33510B-04

Modification Recommended Service Note

33500 Series Waveform Generator

Serial Numbers: MY57101503-MY57802065

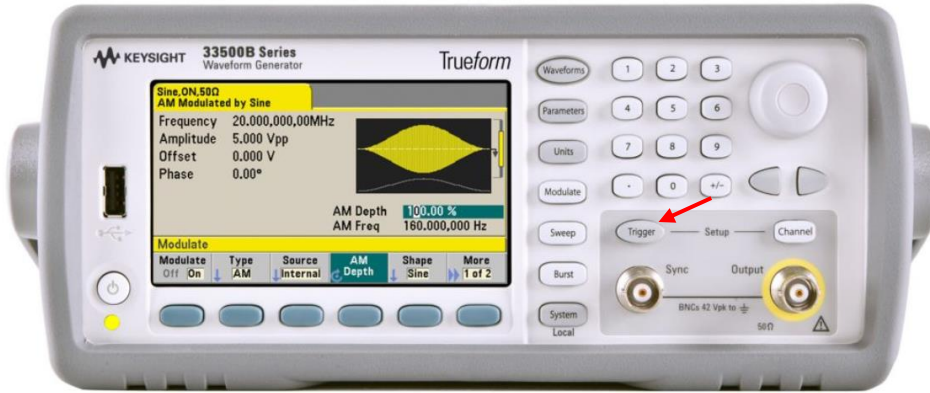
The Problem – The trigger LED  does not blink when burst mode is set to on.

User may experience the trigger LED on the front panel keypad does not blink when burst mode is set to on.

1. Press the Trigger button, set Source to Manual.
2. Set Burst to On.
3. Observe if the LED of the trigger button blinks.

1. Turn on the instrument and perform verification.
2. Replace the front panel board (part number: 33500-66308) if the trigger LED does not blink.
3. Turn on the instrument and verify with the same verification steps after board replacement.
4. Make sure the trigger LED blinks when burst mode is set to on.
